DA/17/2023

RESPONSE TO ASSESSMENT MANAGER'S INFORMATION REQUEST
DEVELOPMENT ASSESSMENT RULES 2017 PART 3 S13
PRELIMINARY APPROVAL (VARIATION REQUEST)
COMBINED RECONFIGURING A LOT (1 INTO 20 LOTS PLUS BALANCE PARCEL)
& MATERIAL CHANGE OF USE FOR A RESIDENTIAL MASTER PLAN
CAPTAIN COOK DRIVE, AGNES WATER
(LOT 2 SP117407)

**INFORMATION REQUEST
PLANNING ACT 2016 S68
DEVELOPMENT ASSESSMENT RULES 2017 PART 3**

**DA/17/2023 - RECONFIGURING A LOT - IMPACT
PRELIMINARY APPROVAL (VARIATION REQUEST) FOR MATERIAL CHANGE OF USE DWELLING
HOUSES, DUAL OCCUPANCY & UTILITY INSTALLATION AND RECONFIGURING A LOT 1 INTO 20 PLUS
BALANCE PARCEL
LOT 2 SP 117407, CAPTAIN COOK DRIVE, AGNES WATER QLD 4677
LOT 2 SP 117407**

Figure 1: Location of Utility Installation

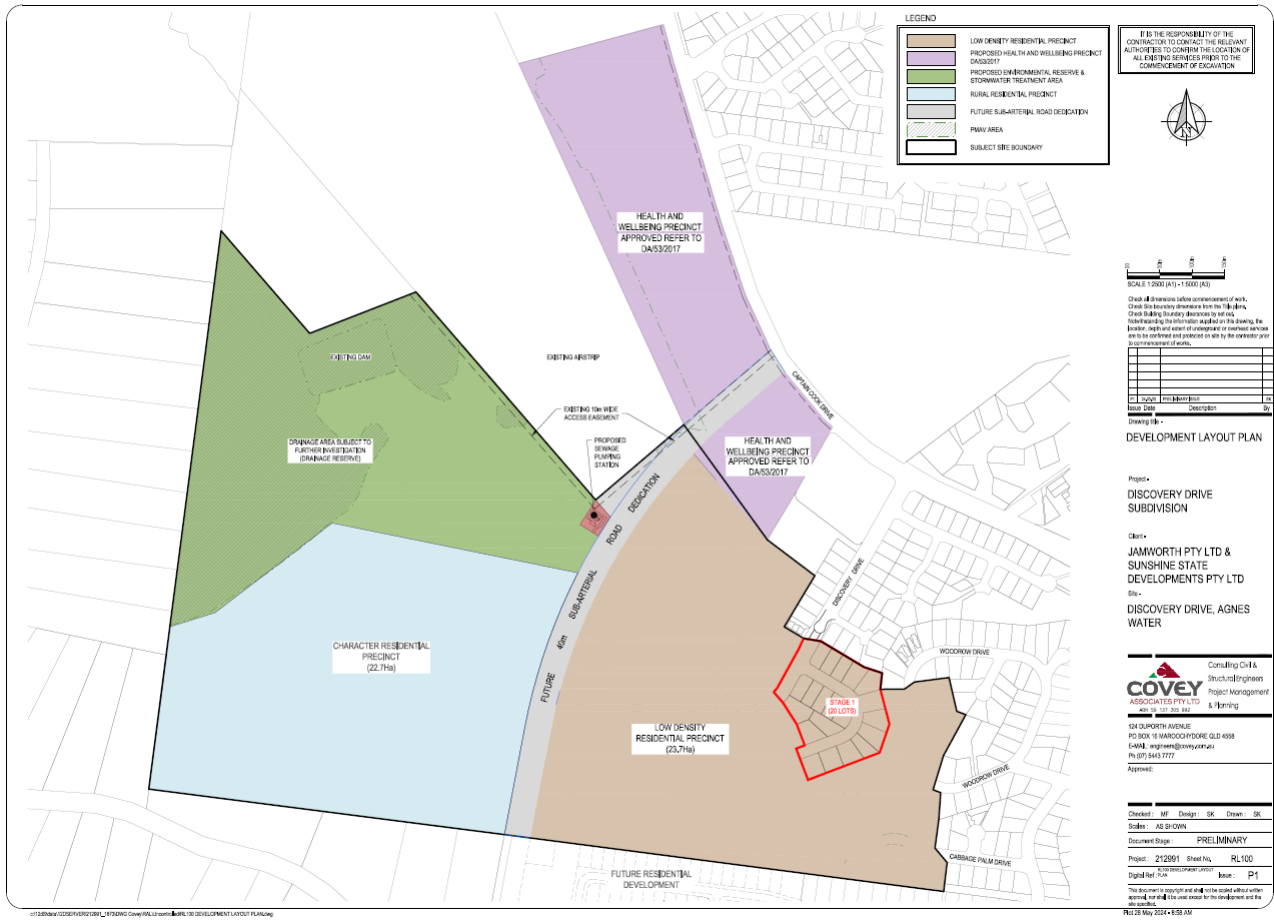
8. **MCU – Public Utility Sewerage Treatment Plant**
Provide updated planning report and assessment against the relevant codes to include reference to this proposed use with the application.

The Public Utility Installation component of the Development Application is for Preliminary Approval only. The original application material shows the indicative location of the plant on its trunk infrastructure alignment, adjoining the future sub-arterial, as reiterated below in **Figure 1**.

The Emerging Community Zone Code does not stipulate any assessment criteria for a utility installation to be assessed against. Furthermore, the Development Design Code only requires development to be serviced by appropriate sewerage disposal infrastructure. Given the Sewer Pump Station has been earmarked as essential trunk infrastructure in Council's LGIP, it is considered that the utility installation automatically complies with this element.

The detailed design of the utility installation will be subject to a future Operational Works application once it is required. As a result, no further detail or assessment is proposed for the utility installation at this time.
